INDESIT company

Model type:
AQSF129EU/HA

Commercial code:
F051745

n4008f00: Thermic link wire removed on three-phase motor

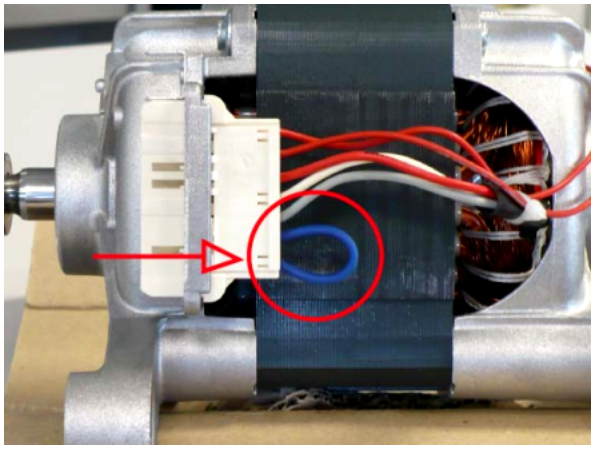
Attention!

When you assist the premodification models using the new motor code you MUST use the thermic link wire code C00265838.

The spare part warehouses will manage the premodification motor until the end of the stock, after they will be replaced with new ones and thermic link wire.

In the attached image you can see the fixing of thermic link wire in the motor therminal box.

TRIPHASE P40 46 L – INOX TUB
C00265827 new motor without thermic link wire - C00116103 premodification motor with thermic link wire

TRIPHASE P40 46 L – PLASTIC TUB
C00265826 new motor without thermic link wire - C00142390 premodification motor with thermic link wire

TRIPHASE P50 52 L
C00265829 new motor without thermic link wire - C00142205 premodification motor with thermic link wire

TRIPHASE P32 46 L TOP LOADING
C00265832 new motor without thermic link wire - C00262375 premodification motor with thermic link wire

TRIPHASE P40 46 L TOP LOADING
C00265834 nuovo new motor without thermic link wire - C00112739 premodification motor with thermic link wire
